Subdivision Authority

File No. LDA08-0350

RE: Tentative plan of subdivision to create 37 single detached residential lots, one (1) medium density residential parcel, one (1) public utility lot, one (1) municipal reserve parcel and one (1) public open space parcel from portions of NE-36-51-25-4, SE-36-51-25-4 and NW-36-51-25-4, located south of 23 Avenue and east of Rabbit Hill Road, **MAGRATH HEIGHTS**

SUBDIVISION CONDITIONS OF APPROVAL MAP

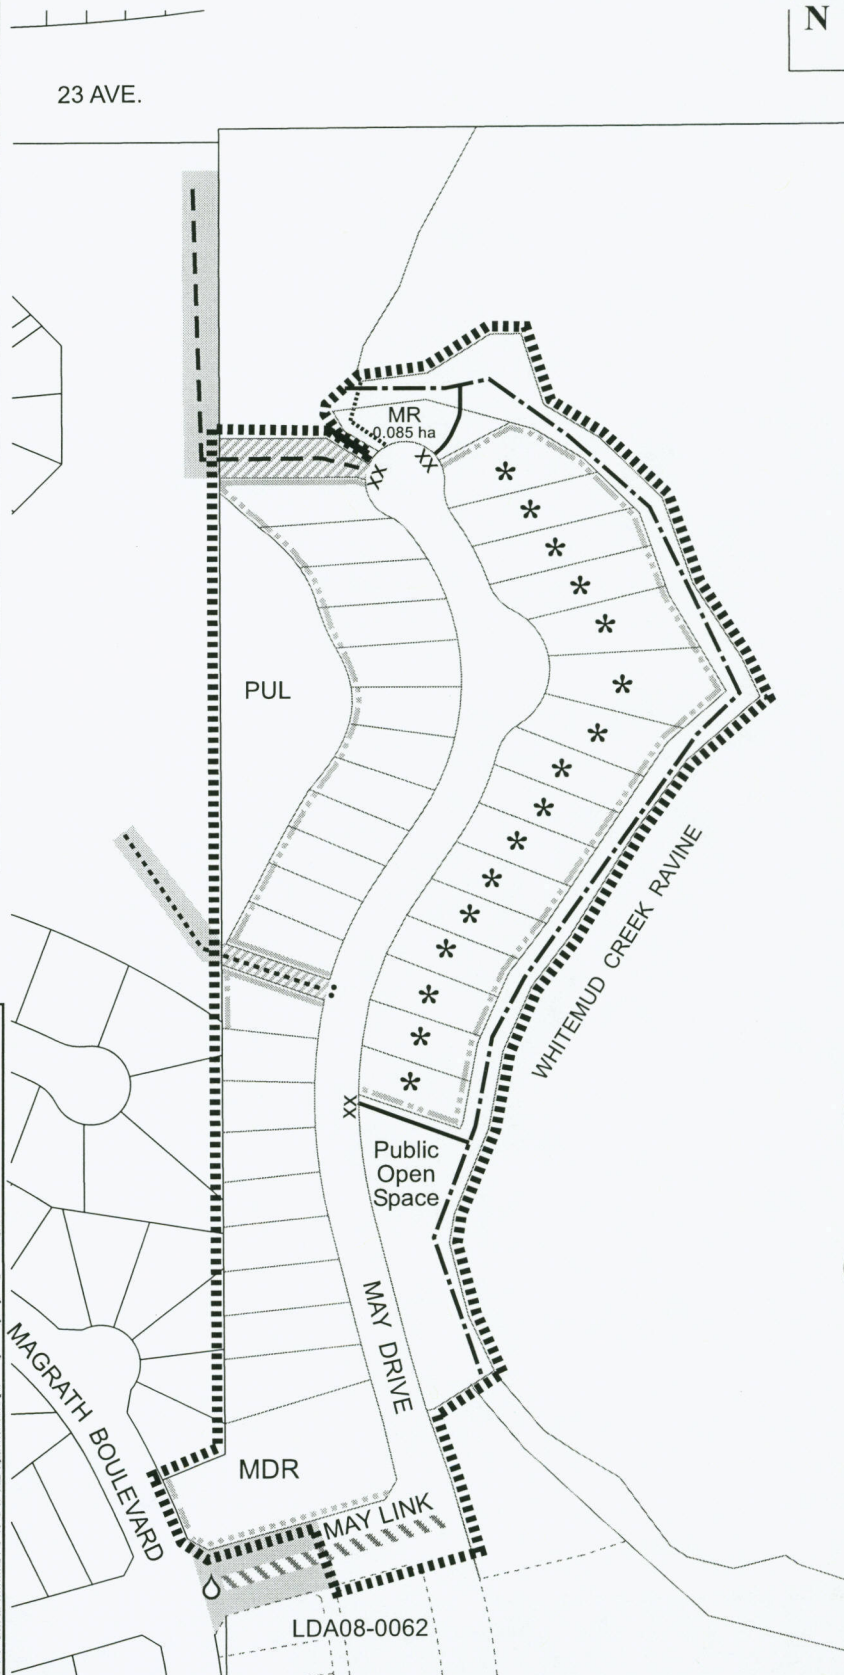
1. that the owner dedicate Municipal Reserve as a 0.085 ha parcel, pursuant to Section 666 of the Municipal Government Act, as shown on the "Conditions of Approval" map, Enclosure I;

2. that the owner enter into a Servicing Agreement with the City of Edmonton, pursuant to Section 655 of the Municipal Government Act;
3. that the owner prepare a restrictive covenant in favour of the City of Edmonton that will be registered against the lots backing onto the top-of-bank as per the applicable development restrictions shown by the Thurber Engineering Ltd. Geotechnical Investigation Report No. 19-423-46, February 17, 2006 and the addendum letter (19-5334-0) dated April 29, 2008, as shown on the "Conditions of Approval" map, Enclosure I;

4. that the owner register the emergency access and walkways as legal road rights-of-way, as shown on the "Conditions of Approval" map, Enclosure I;
5. that the subdivision boundary be amended to exclude a 1.5 m wide portion of land along the western boundary of the MR parcel (0.085 ha), as shown on the "Conditions of Approval" map, Enclosure I;

8. that the Engineering Drawings include construction of the required offsite or onsite water distribution mains, to the satisfaction of EPCOR Water;
9. that the Engineering Drawings include the required upgrade to the existing 200mm water main stub at Magrath Boulevard and May Link to 250 mm, to the satisfaction of EPCOR Water, as shown on the "Conditions of Approval" map, Enclosure I;

10. that the owner construct an emergency access walkway containing a hard surface trail, 3.0 m wide or greater, with a 12 m centerline turning radius, including t-bollards and lighting, as shown on the "Conditions of Approval" map, Enclosure I;

11. that the owner construct a 3.0 m asphalt multi-use trail with a dividing yellow centerline and "shared use" signage within the top of bank setback area, as shown on the "Conditions of Approval" map, Enclosure I;

12. that the owner construct a 1.5 m concrete sidewalk with bollards and lighting, as shown on the "Conditions of Approval" map, Enclosure I;
13. that the owner construct a 3.0 m asphalt multi-use trail connection with t-bollards, to provide a link into the existing trail system, as shown on the "Conditions of Approval" map, Enclosure I;

14. that the owner construct all fences positioned wholly on privately owned lands as shown on the "Conditions of Approval" map, Enclosure I; and
